Informal document **GRPE-74-03**
74th GRPE, 9-13 January 2017,
agenda item 3(b)

**Proposal for amendments to ECE/TRANS/WP.29/GRPE/2017/7
(Consolidated version)**

This document shows the amendments to ECE/TRANS/WP.29/GRPE/2017/7 proposed in GRPE-74-02 as a consolidated version. Modifications to ECE/TRANS/WP.29/GRPE/2017/7 are marked in track changes.

Global technical regulation on Worldwide harmonized Light vehicles Test Procedures (WLTP)

Figure A8.App1/4

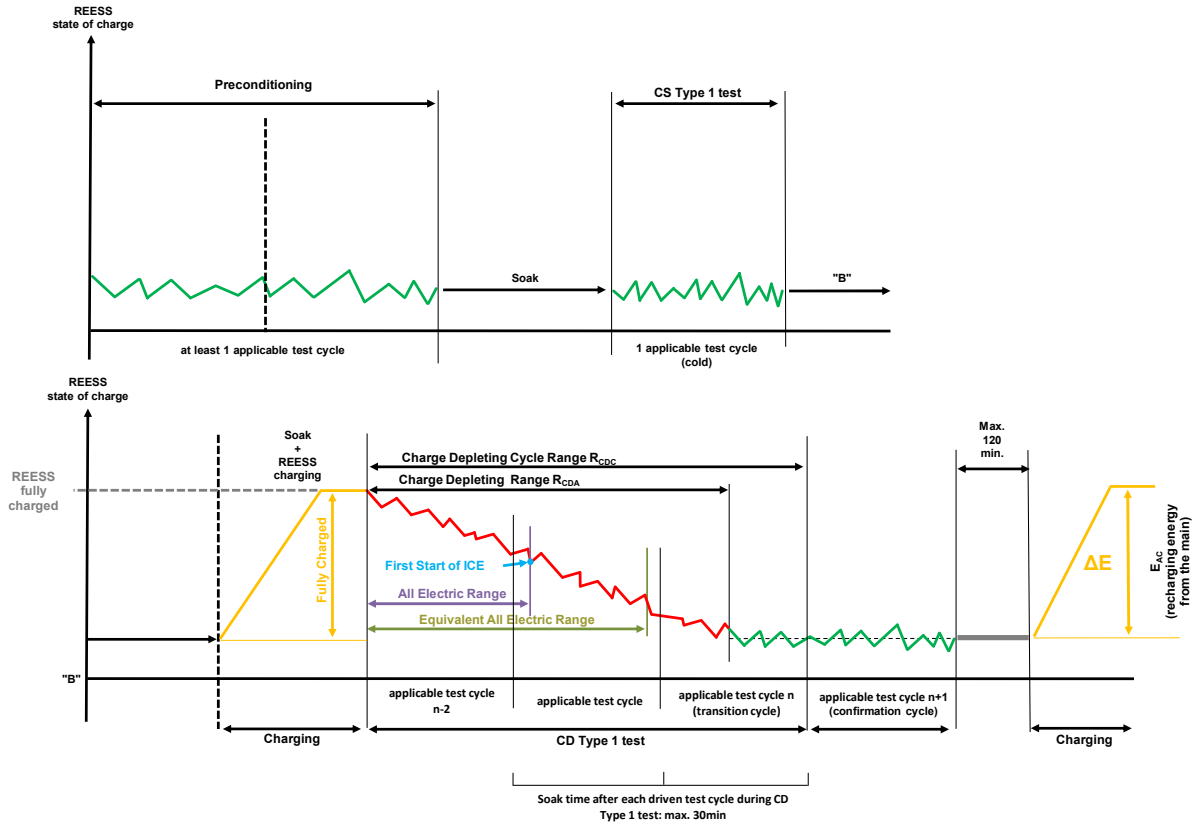
OVC-HEVs, charge-~~depleting~~-sustaining Type 1 test with subsequent charge-~~sustaining~~-depleting Type 1 test
